SAN ANTONIO WATER SYSTEM
FAR WEST SEWER RELIEF MAIN (FW-01)
SAWS Job No. 09-2501
Solicitation No. B-11-052-RA

ADDENDUM NO. 3

October 05, 2011

REVISIONS	
	FAR WEST SEWER RELIEF MAIN (FW-01)
SAN ANTONIO WATER SYSTEM	
CONT.	BUDGET PROJ.
SUBMITTED	
APPROVED	
MAP No. 104-566, 106-566, 108-568, 108-570	SHEET 3
SECT. No.	3
DR. TM CK. HMC	JOB No. 09-2501 OF 48

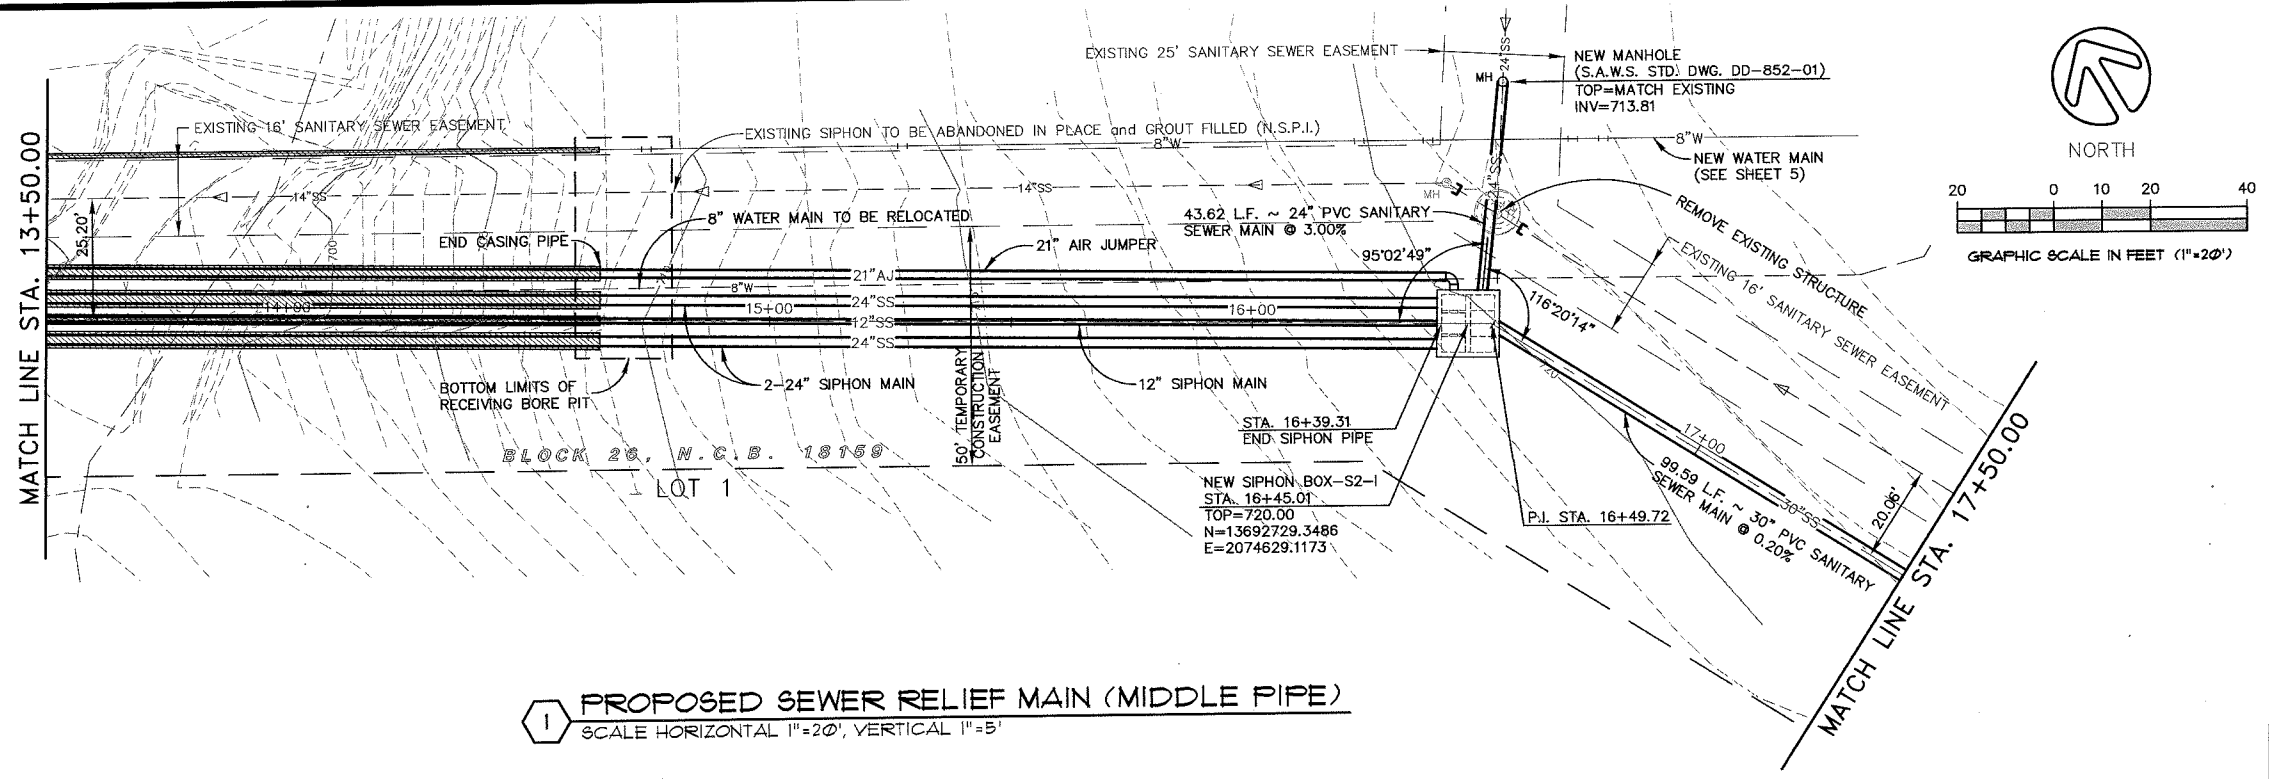
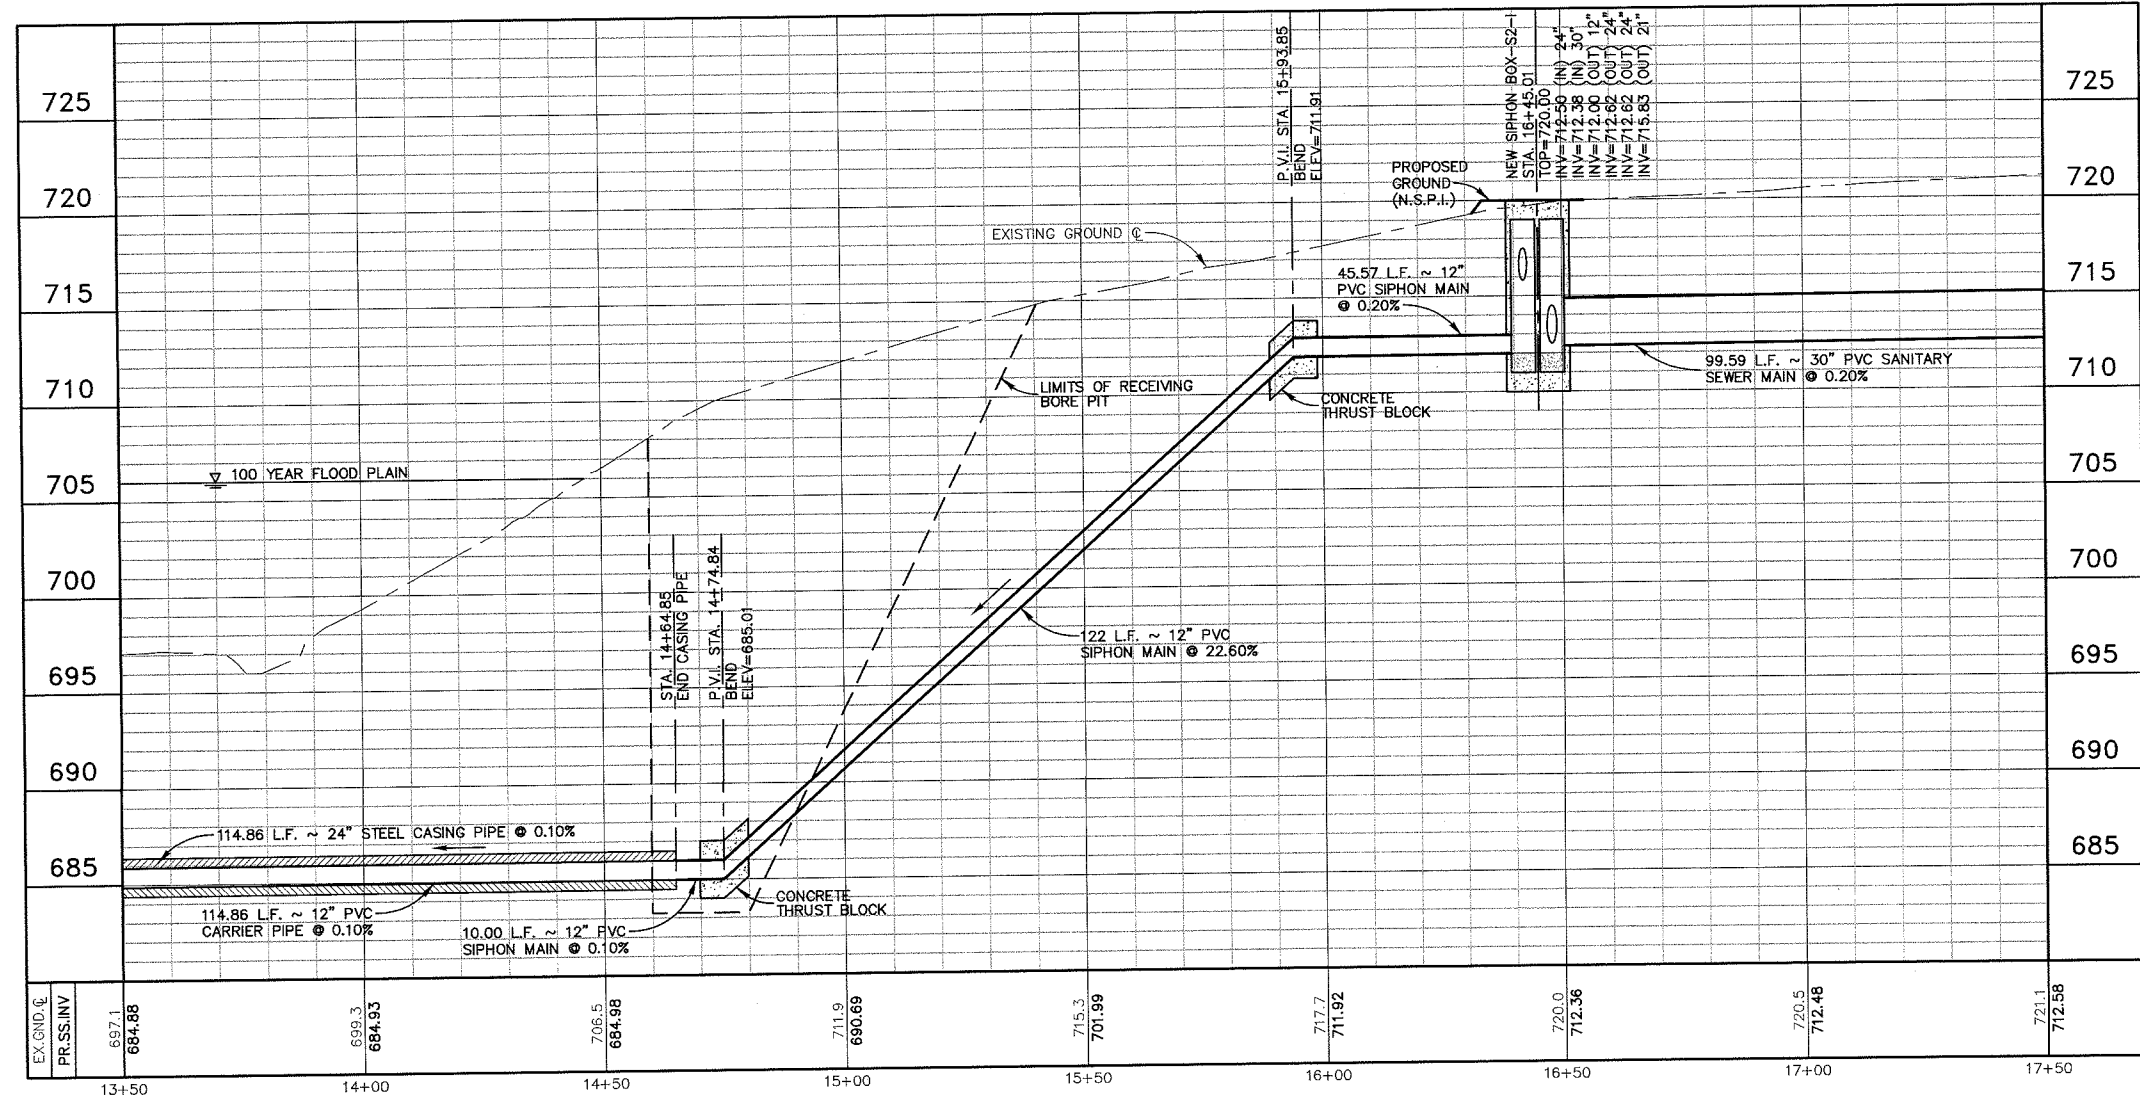
- 1) On plan set sheet 10, item number *852.3 Extra Depth Manhole*, has been added. Please replace sheet 10 with the enclosed re-issued sheet.
- 2) On plan sheets 3, 13, 15, 16, and 21, item number *852.1 Sanitary Sewer Structures*, has been replaced with item number *850 Sanitary Sewer Structure*. Please replace the above mentioned sheets with the enclosed re-issued sheets.
- 3) In Addendum No. 2, Revisions to Contract Note 1, it was stated that *Item 848 21" PVC Sanitary Sewer Line (6' – 10')*, *720 Linear Feet (L.F.)*. The linear footage has been confirmed to be 710 LF of pipe.
